March 12, 1990

Subject: Byron Station Units 1 and 2
Braidwood Station Units 1 and 2
Supplement to Application for Amendment to
Facility Operating Licenses
NPF-37, NPF-66, NPF-72 and NPF-77,
Appendix A, Technical Specifications
NRC Docket No.s 50-454, 50-455,
50-456 and 50-457

SAFETY EVALUATION AND ENVIRONMENTAL ASSESSMENT FOR PROPOSED CHANGES

FIGURE 1

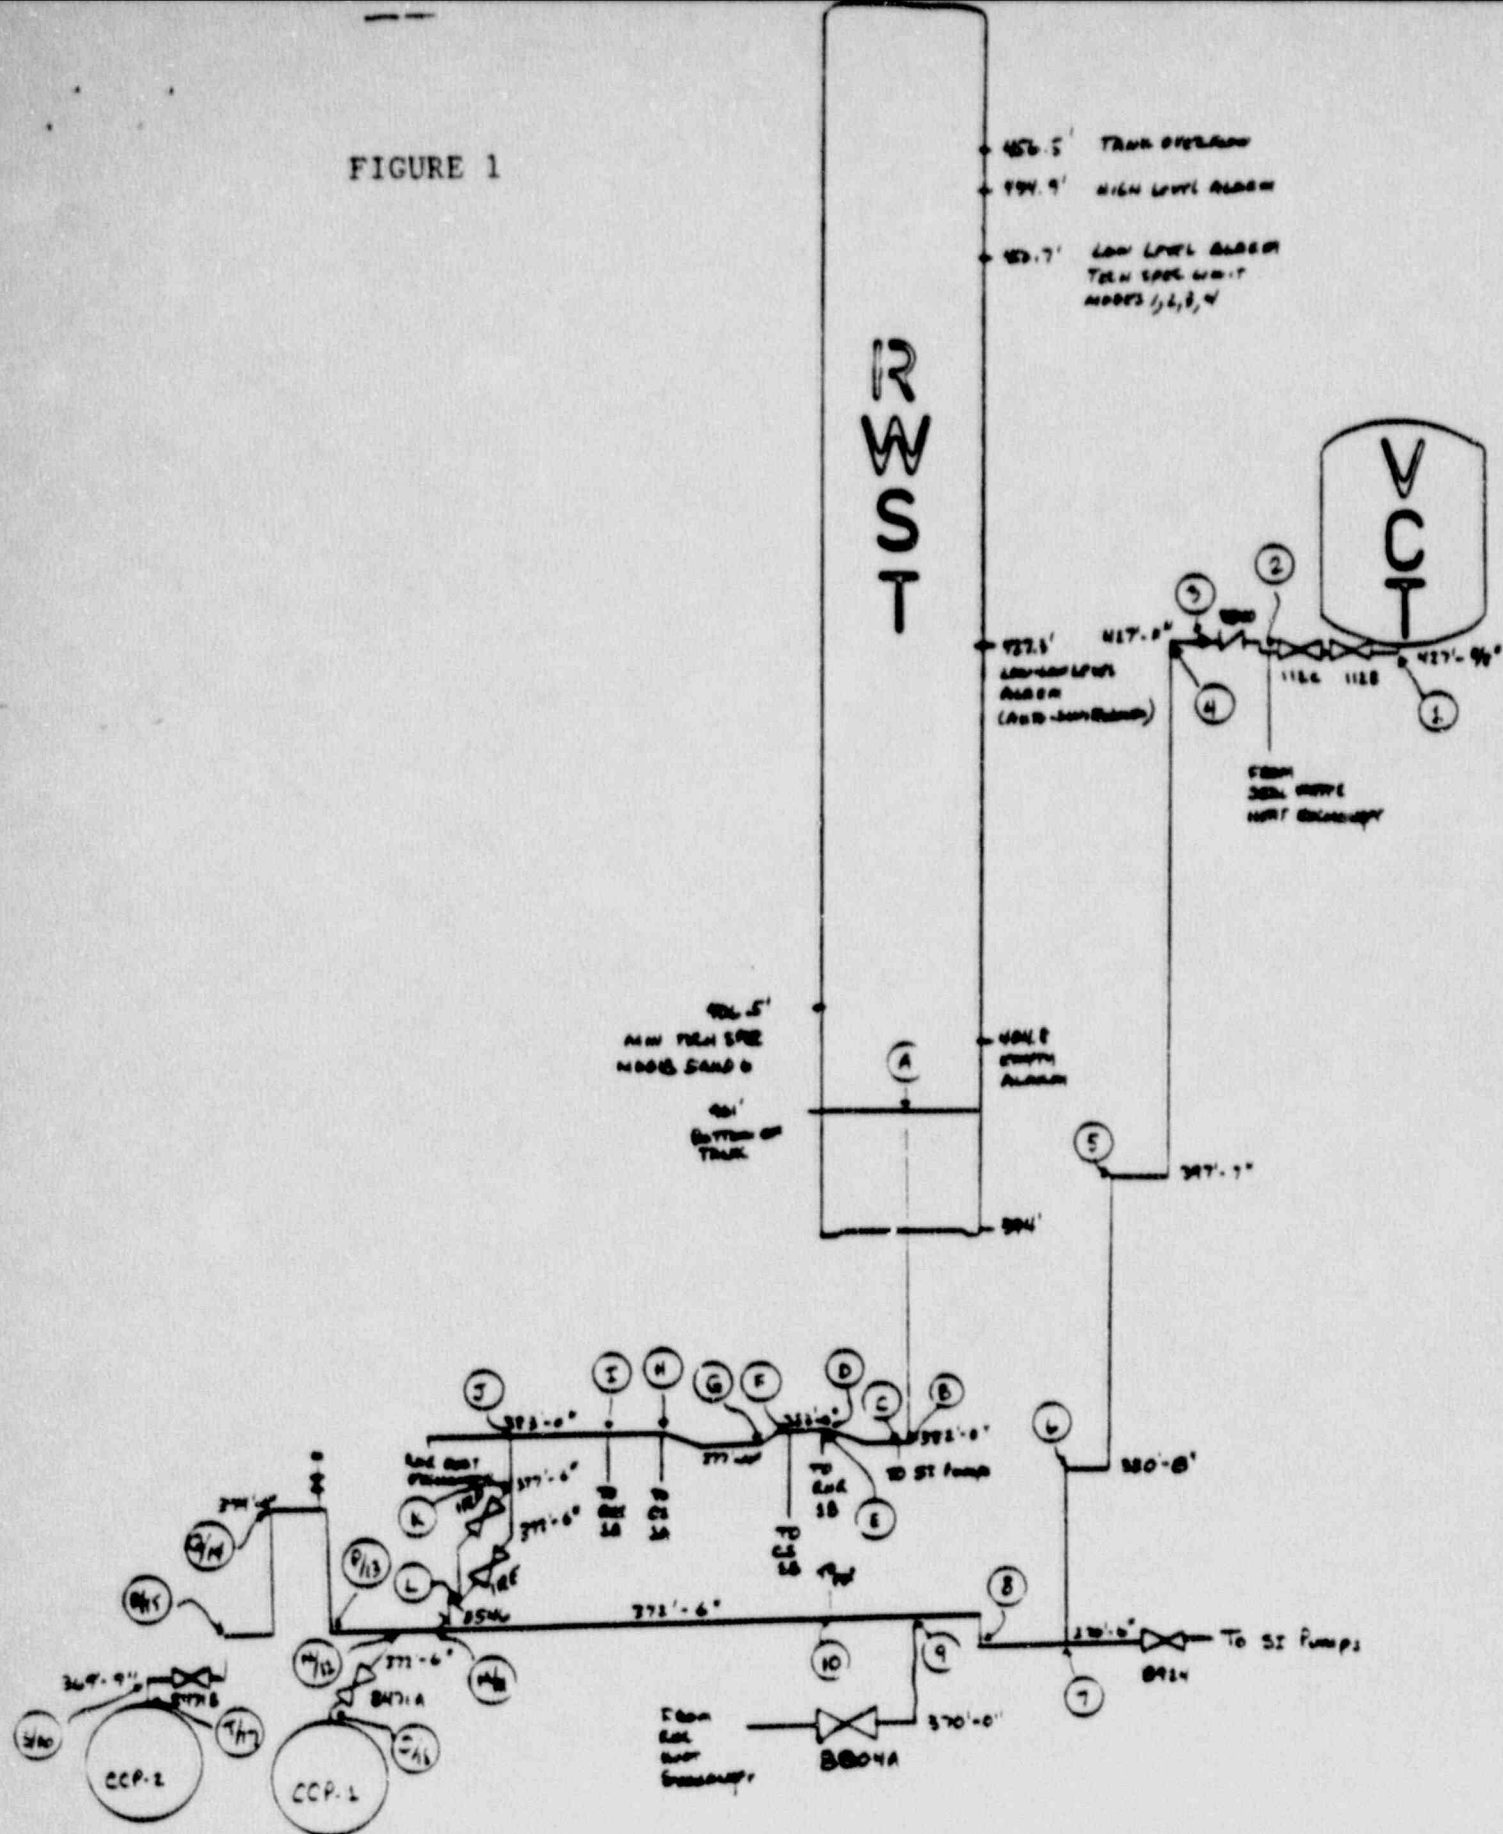
Item A.1: Provide feedback on industry experience regarding venting. Include IN 88-23, Supplement 1 and why it is not applicable.

A compilation of the elevation diagram of the RWST and VCT to CCP suction is provided in Figure 1. It should be noted that both the Farley and South Texas events were caused by extreme high points in the ECCS pump suction line relative to either the VCT or RWST. Byron and Braidwood Stations do not have high points in the ECCS pump suction lines of the magnitude found at the Farley and South Texas plants.

Response: Edison's response to the Farley event is shown in Table 1. This table summarizes calculations done to determine if hydrogen could come out of solution in the VCT to CCP suction line by calculating the delta-pressures between various points in the piping line and the VCT outlet. If this delta-pressure is positive it can be concluded that the hydrogen introduced in the VCT will remain in solution at that point in the system. Additionally, high points were identified and all connections were evaluated for collection of hydrogen. It was determined that the Byron and Braidwood Units are not susceptible to the type of hydrogen accumulation identified at Farley.

Edison's response to the South Texas event is shown in Table 2. This table summarizes calculations performed to determine if pressures less than atmospheric could exist in the CCP suction line when suction is transferred from the VCT to the RWST by calculating the delta pressures between various points in the piping line and the RWST outlet (assuming the RWST is empty). Since this delta-pressure is positive it can be concluded that the South Texas event is not credible at the Byron and Braidwood Stations.

Figure 2

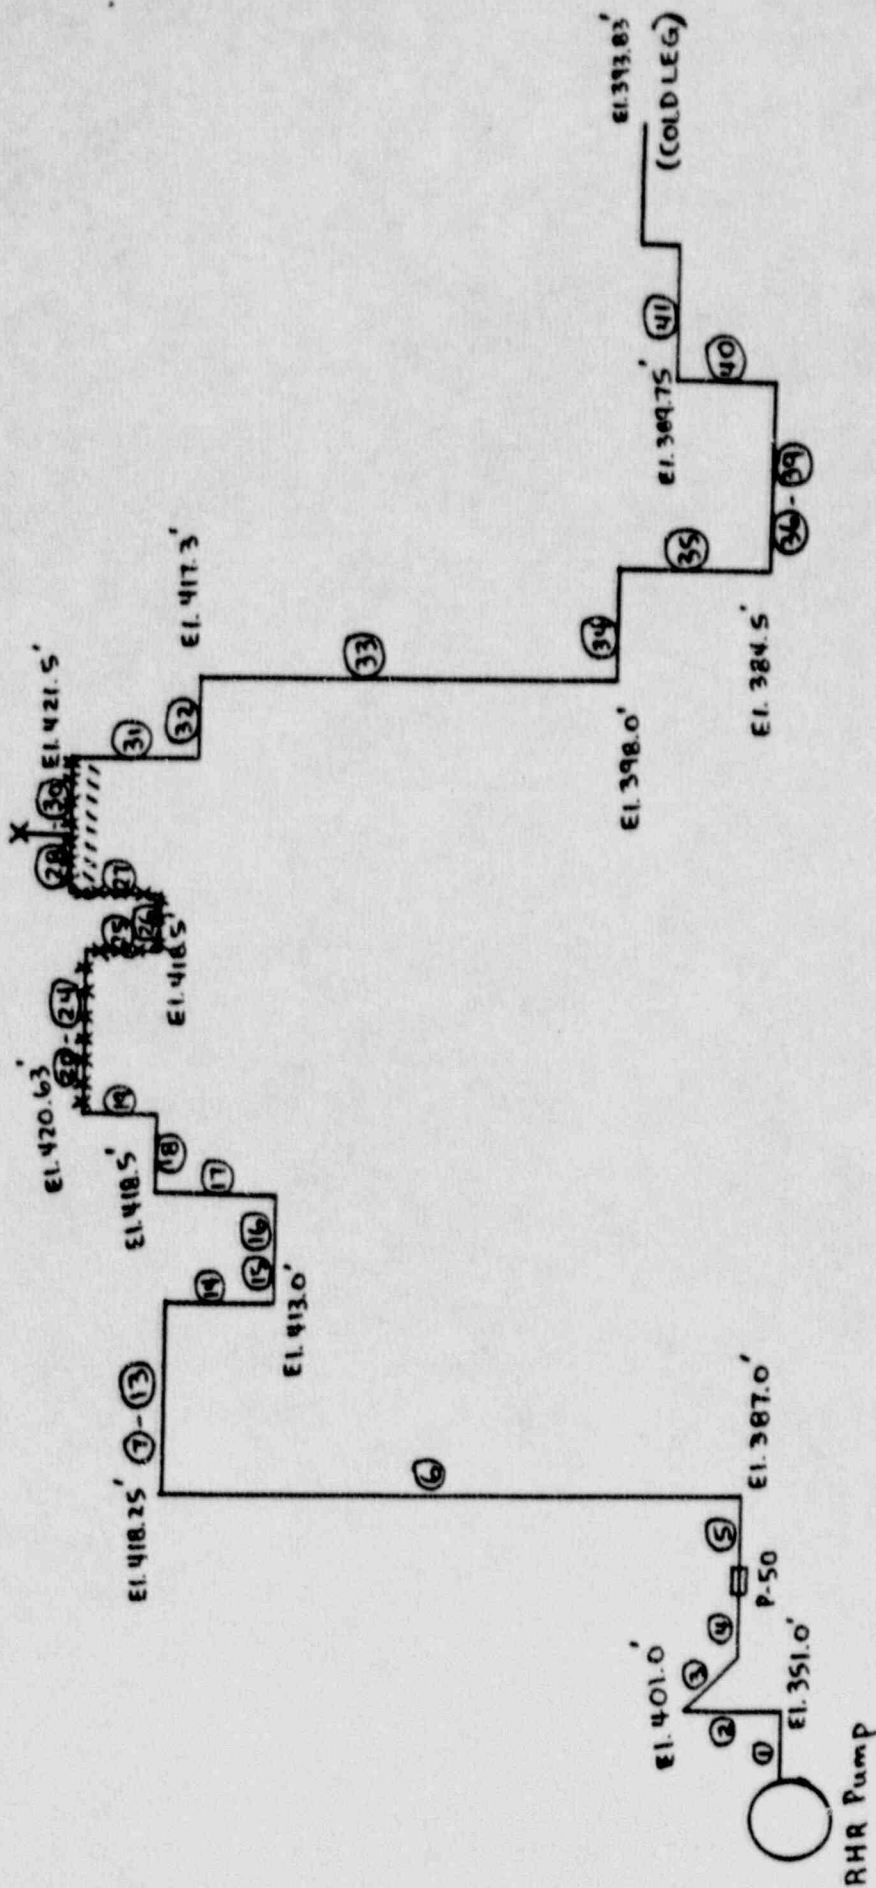
Item B.4: Provide a "waterhammer" analysis based on postulated air sources. Also document the worst case scenario that represents a line that is completely filled with air on the discharge side of the RHR pump.

As a worse case estimate, the RHR ECCS supply line to loop 1, inside the containment, was studied. The line has the largest diameter piping, a long pipe length, and high elevation segments. Figure 1 is a profile of the piping. Figure 2 shows the location of the assumed air pocket and the number of the pipe segments. Table 1 tabulates the forces for a large bubble case.
